The application of 4M change

Supplier: Zhe Jiang Rectron Electronic Co,. Ltd

Item	RL151-RL157
P/N	RL151-RL157

Content (Before) :

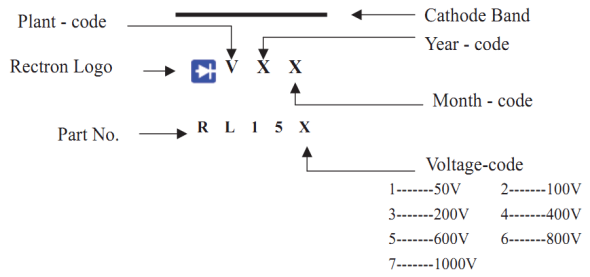
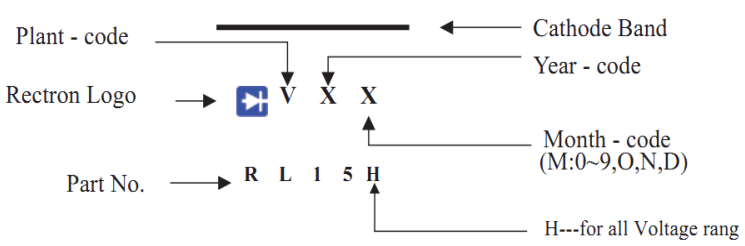
1) Device body marking change from "RL151", "RL152"…etc to "RL15H".

2) Maximum Recurrent Peak Reverse Voltage (Vrrm) rating upgraded as below.

RL151 from 50V to 1000V RL154 from 400V to 1000V RL156 from 800V to 1000V

RL152 from 100V to 1000V RL155 from 600V to 1000V RL157 no change

RL153 from 200V to 1000V

3) No other fit, form or function changes
